Florida Power & Light Company, 6351 S. Ocean Drive, Jensen Beach, FL 34957

Re: St. Lucie Unit 2
Docket No. 50-389
Proposed License Amendment
RCS Pressure/Temperature Limits

ATTACHMENT 1

St. Lucie Unit 2 Marked-up Technical Specification Page

FIGURE 3.4-2 21.7
ST. LUCIE-2 P/T LIMITS, ~~15~~ EFPY
HEATUP AND CORE CRITICAL

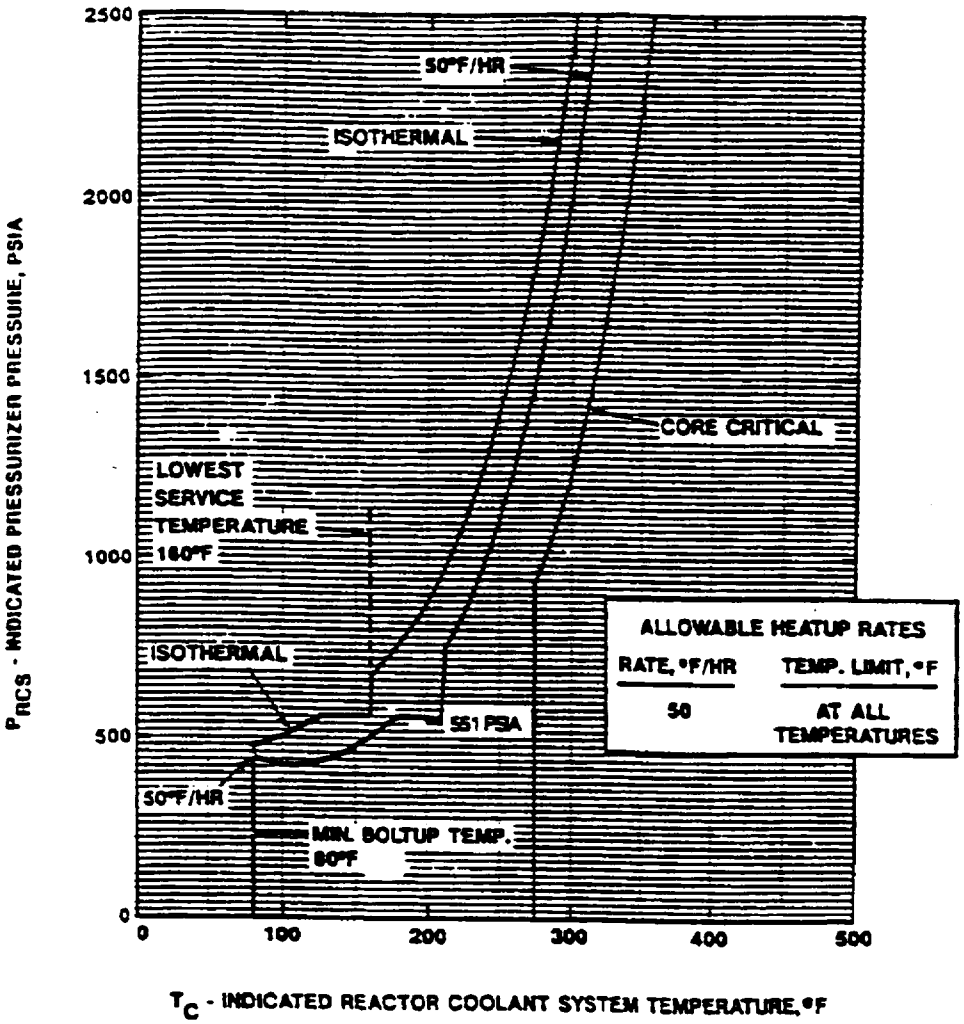
2. LCO 3.4.9.1 currently provides the pressure and temperature limits in terms of Figures 3.4-2, 3.4-3, and 3.4-4 for the RCS (except the pressurizer) during heatup, cooldown, criticality, and inservice leak and hydrostatic testing for 15 EFPY. The proposed amendment would use these existing figures, as-is, and only revise the title by changing ***15 EFPY*** to ***21.7 EFPY***.

Figure B 3/4.4-1

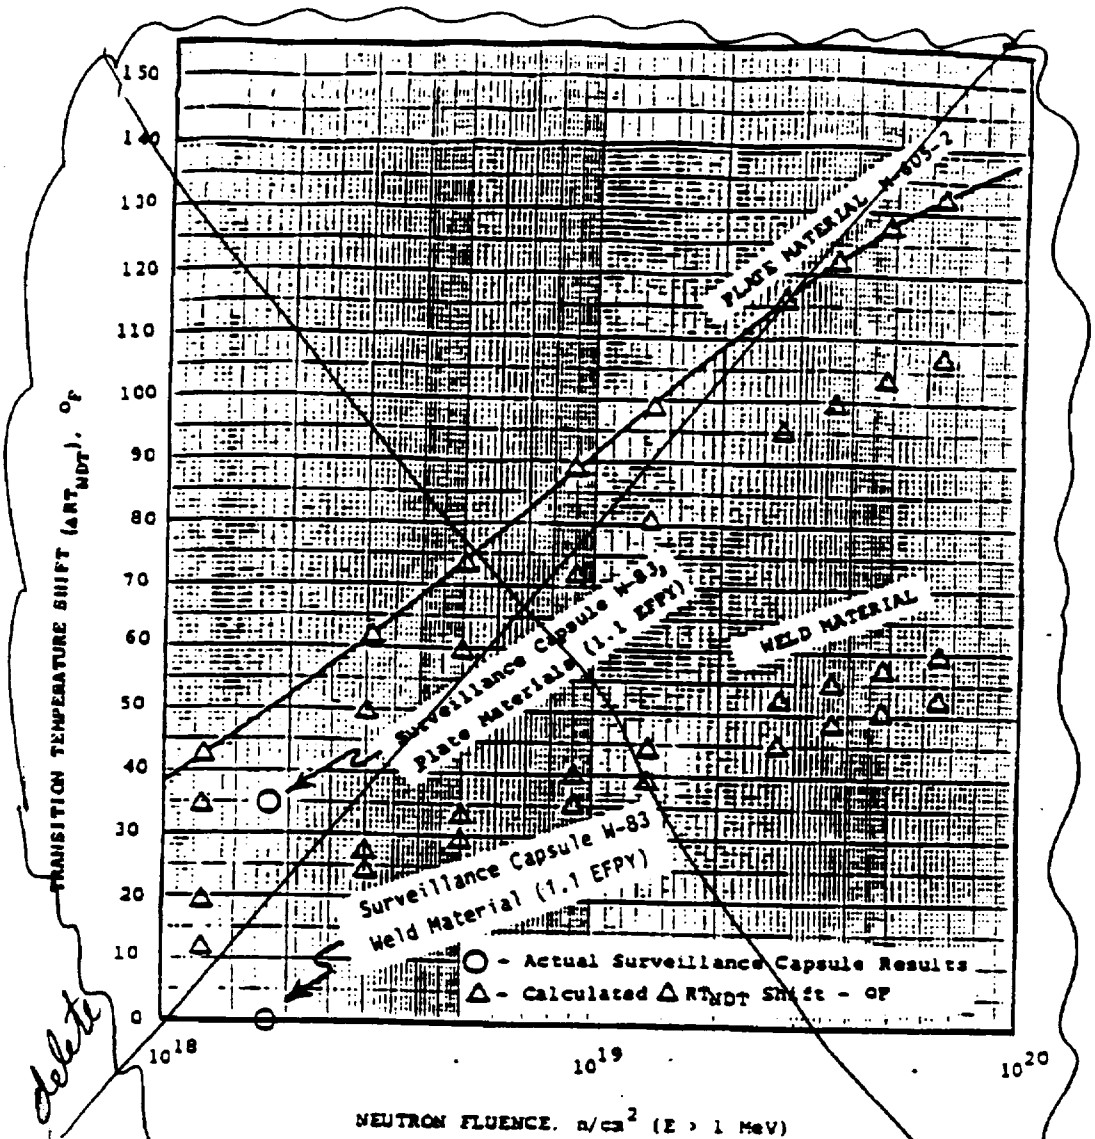
4. Changed the TS 3/4 4.9 Bases as indicated to be consistent with this proposed amendment. The change to the Bases deletes the obsolete Figure B3/4.4-1 on page B3/4 4-10.

Delete
